UNITED STATES PATENT AND TRADEMARK OFFICE

APPLICATION NO.	FILING DATE	FIRST NAMED INVENTOR	ATTORNEY DOCKET NO.	CONFIRMATION NO.
10/729,760	12/05/2003	Kenneth C. Boyle	P06090US00	3212

Office Action Summary

FINAL OFFICE ACTION

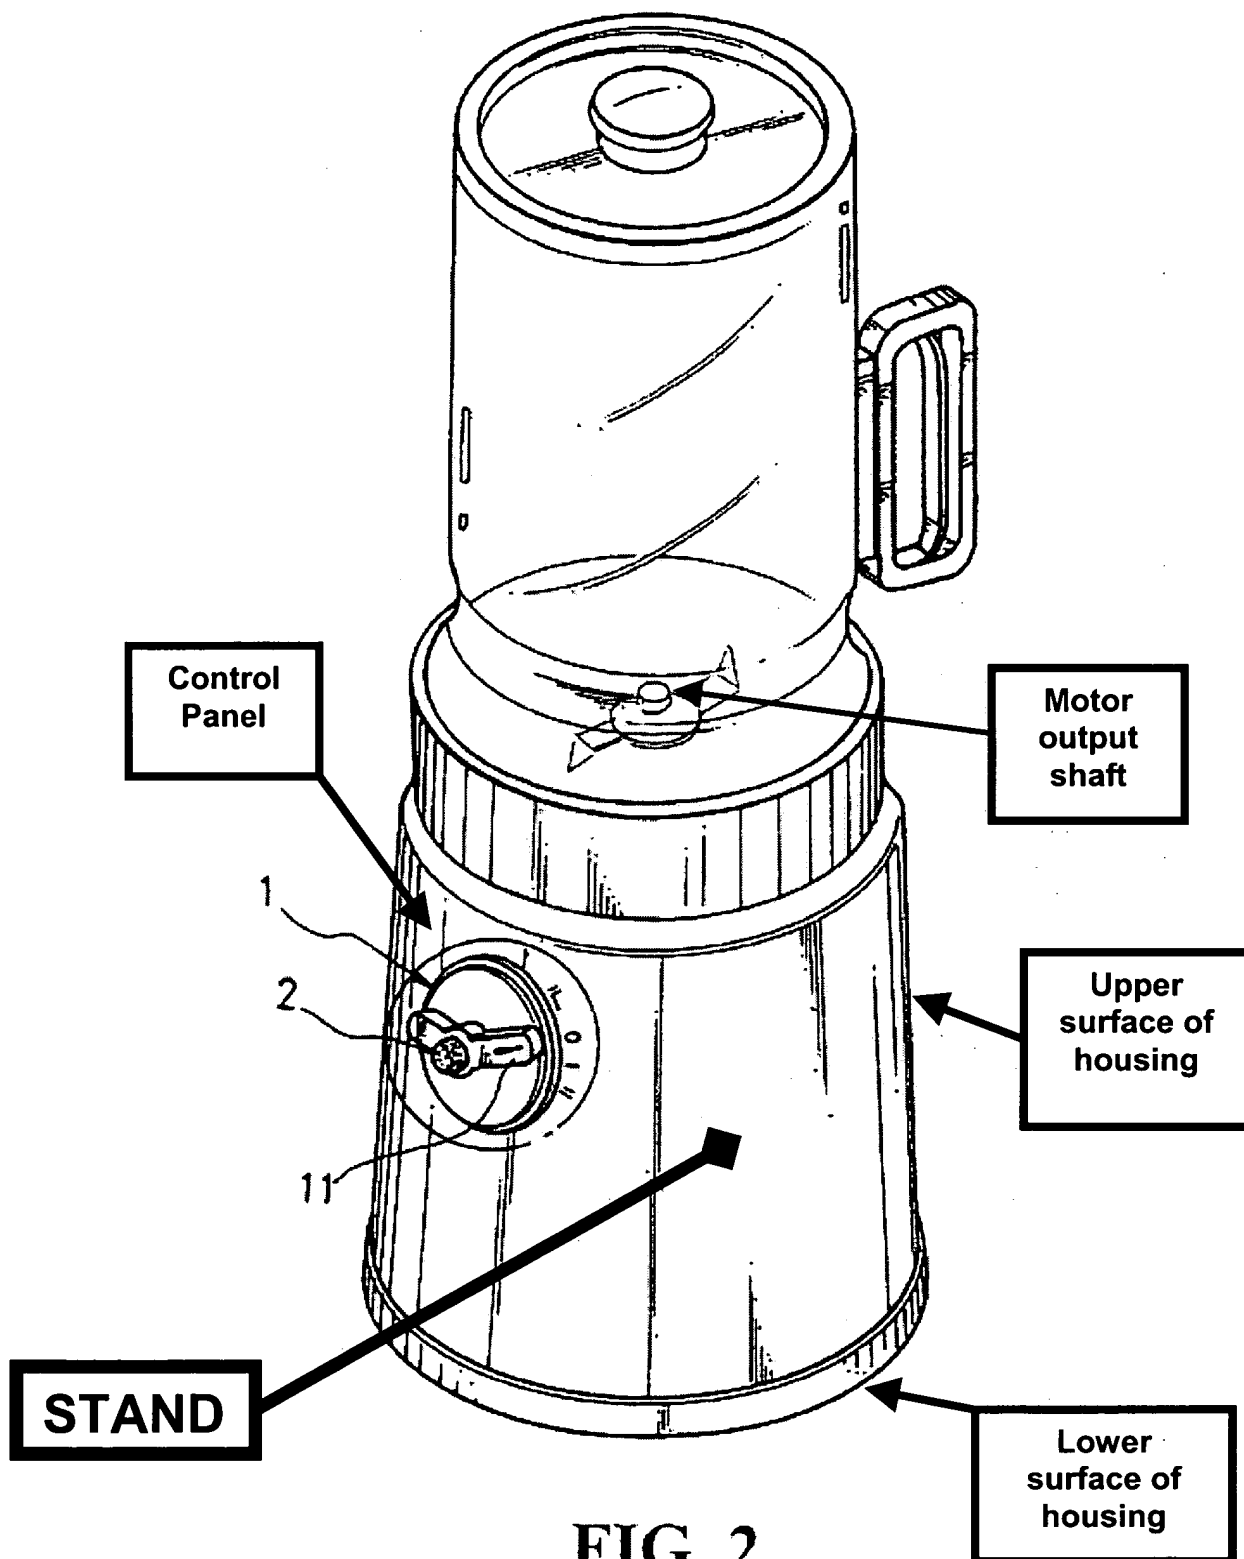
5. **Claims 1, 2, 4, 11, 12, 15, 16, 17, 18, 23, 24, 25, and 26 are rejected under 35 U.S.C. 102(e) as being anticipated by Lin (US 6,599,006 B1).**

The patent to Lin (US 6,599,006 B1) discloses a mixer control method and a mixer with a housing or stand (and thus a "STAND MIXER") as labeled below, the housing or stand having an upper surface disposed above a lower surface (as seen

below in Fig. 2); a motor within the housing connected to an output shaft; a control panel on the housing having a rotary or rotatable dial 1 that is adjustable to select an incremental motor speed and a power button 2 located in the center of the rotary dial 1 for starting the motor of the mixer; a speed indicator with multiple speed locations disposed radially from an axis of the dial as seen in Figs. 2, 3, and 5; the control panel on the upper surface of the housing; the dial having speed indicia including an off position "O" and a standby position "IL"; the power button 2 having a stop position as seen in Fig. 5; the speed indicator on the upper surface of the housing having speed indicia with multiple speed locations (the indicia "IL", "O", "I", and "II") that indicates the corresponding incremental speed of the motor.

Referring to FIG. 2, there is shown a disc-type rotating switch 1. The rotating switch 1 comprises a stop button, speed I rotation, speed II rotation, and an instantaneous rotation. The rotating switch 1 is in combination with a single fully automatic control key 2 which contains an IC program positioned at the central position of the rotating shaft 11 of the rotating switch 1. The control key 2 is operated by pressing of the key. For instance, the first pressing of the key 2, which enables automatic mode and then stops (with a warning), or in the course of automatic operation, the key 2 is pressed once to cause the rotation to stop.

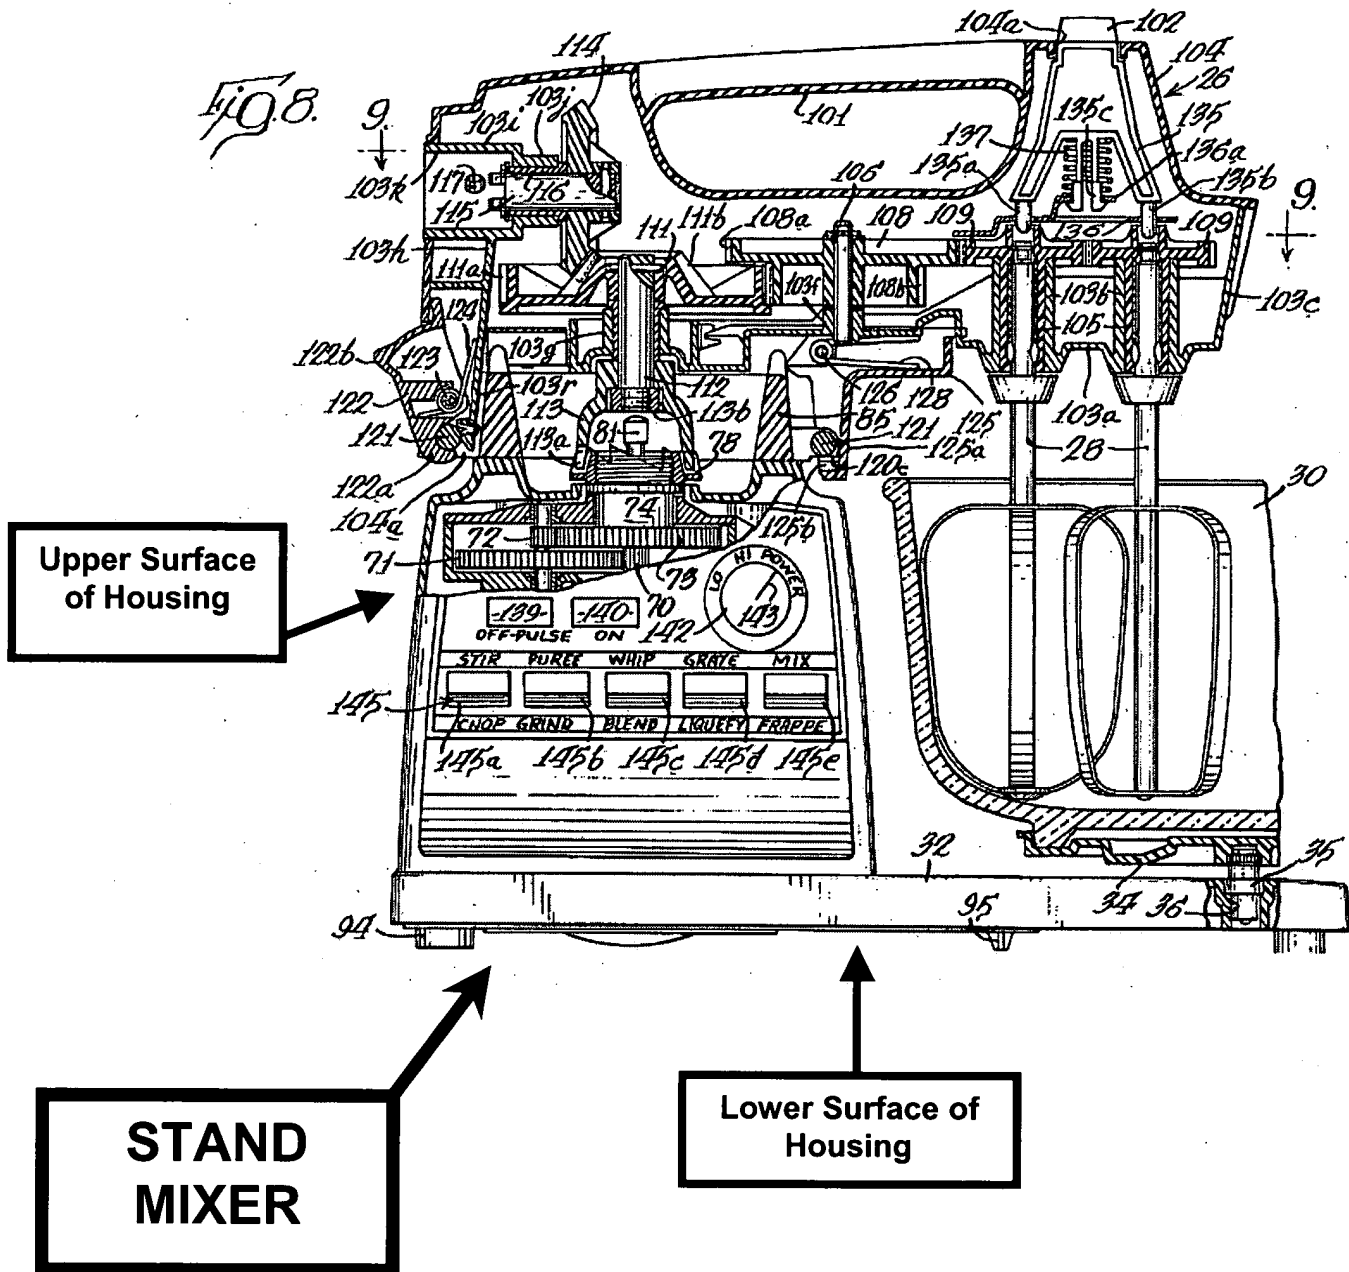
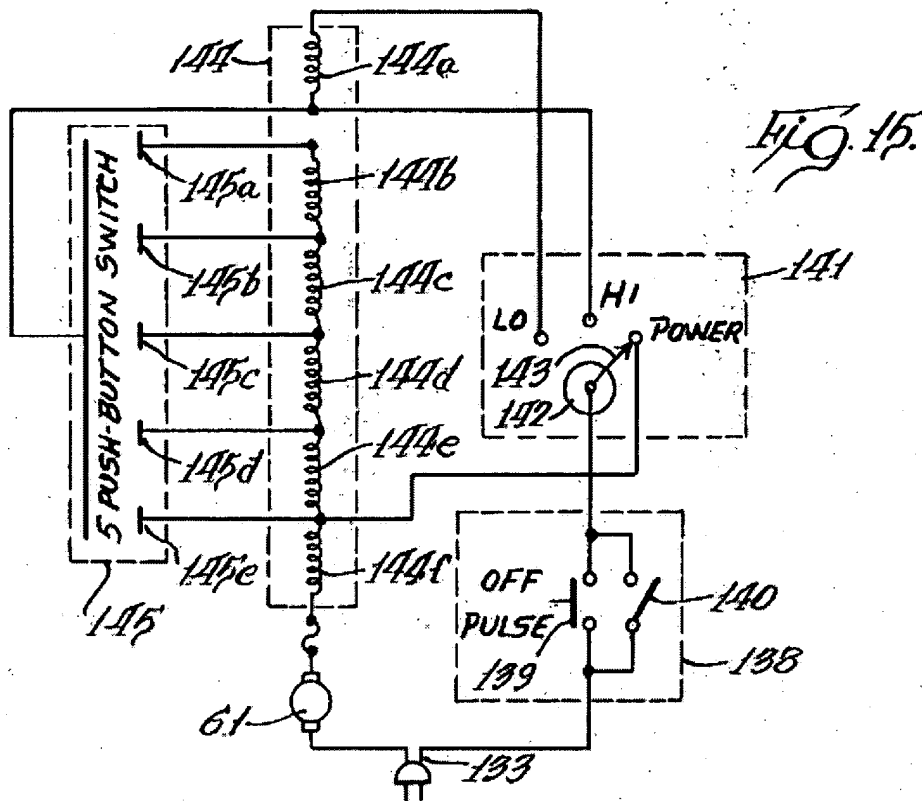
6. Claims 18 and 23 are rejected under 35 U.S.C. 102(b) as being anticipated by Ernster et al. (US 3,951,351).

The patent to Ernster et al. '351 discloses a stand mixer (Figs. 1, 2, 4, 8, and 15) with a housing 24, 32 having an upper surface (as labeled below) disposed above a lower surface 32; a motor 46 within the housing connected to an output shaft 62; a control panel (Figs. 1, 2, and 8) on the housing having a power switch 141, a rotatable speed selector 142 to change motor speed, and a speed indicator 143 with speed indicia (Fig. 8) located on the upper surface of the housing; the control panel being located on the upper surface of the housing as seen below.

7. Claims 24 and 25 are rejected under 35 U.S.C. 102(b) as being anticipated by Ernster et al. (US 3,951,351).

The patent to Ernster et al. '351 discloses a stand mixer (Figs. 1, 2, 4, 8, and 15) with a housing 24, 32 having an upper surface (as labeled below) disposed above a lower surface 32; a motor 46 within the housing connected to an output shaft 62; a control panel (Figs. 1, 2, and 8) comprising a rotary dial speed selector 142 to change motor speed; the control panel being located on a top portion of the upper surface of the housing as seen below; the control panel having a speed indicator 143 and a power button 140 actuable by a user for starting the motor 46 (see Fig. 15).
